**OSTA's Public Comment on CEC
Preliminary Staff Assessment of Cultural
Resources, in conjunction with the license
application for Hidden Hills Solar Energy
Generation System (HHSEGS)**

Submitted July 23, 2012

The Old Spanish Trail Association submits the following comments regarding the California Energy Commission's Preliminary Staff Assessment (PSA), particularly the section dealing with cultural resources, which was issued on June 15, 2012.

Figure 1. Map showing proximity of HHSEGS to other potential solar plants

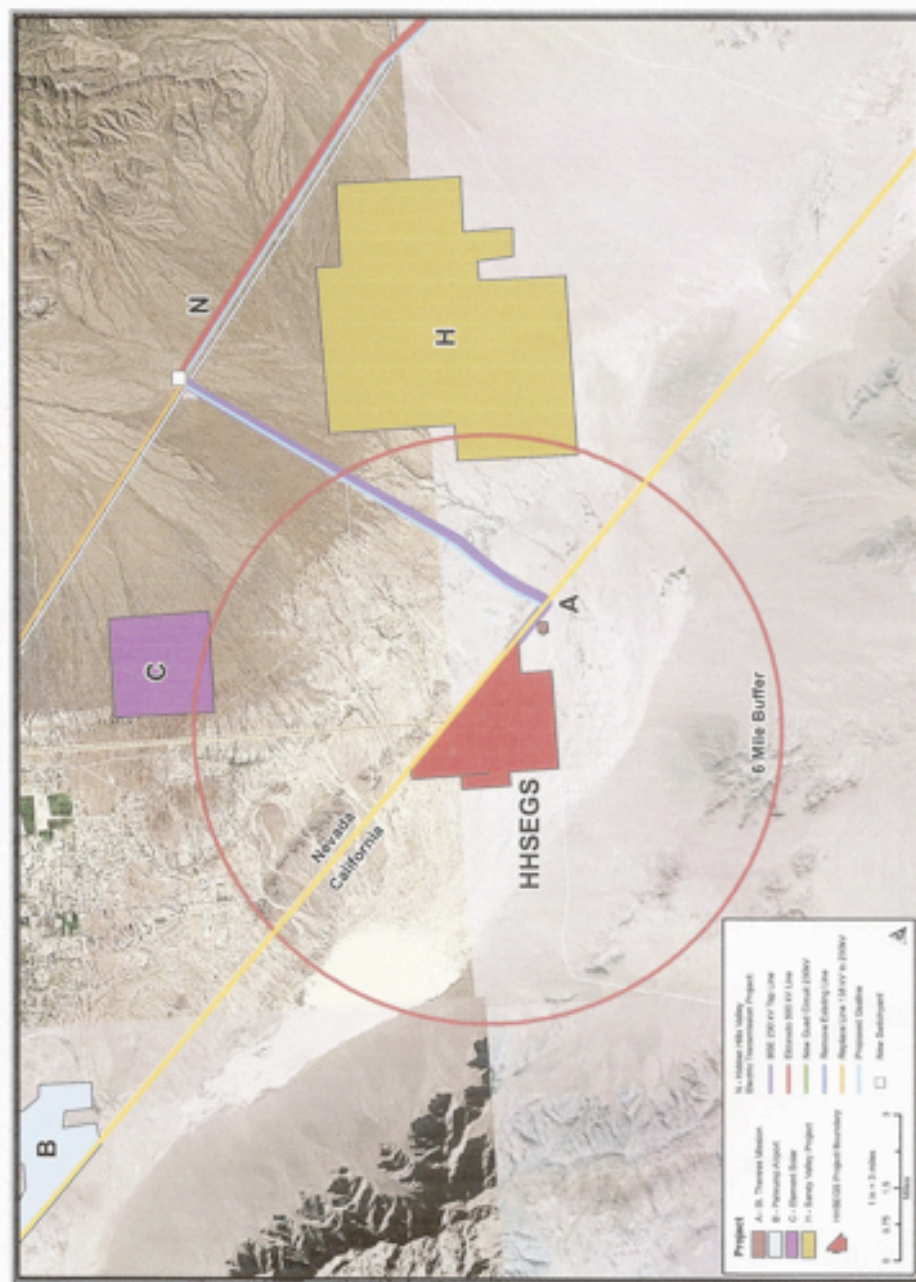
Two other possible solar projects are planned for the area near HHSEGS. As Figure 1 (following page) shows, the Sandy Valley Project and the Element Solar Project both fall partly within a six-mile radius of HHSGES.

The combined effect of these projects, proposed on vast tracts of relatively undisturbed open land, will result in fundamental changes in how the desert and the OSNHT/MR are experienced by the public. The cumulative effects of these projects will also result in substantial impacts to a wide range of environmental resources in the local desert. These include impacts to biological resources and ground water.
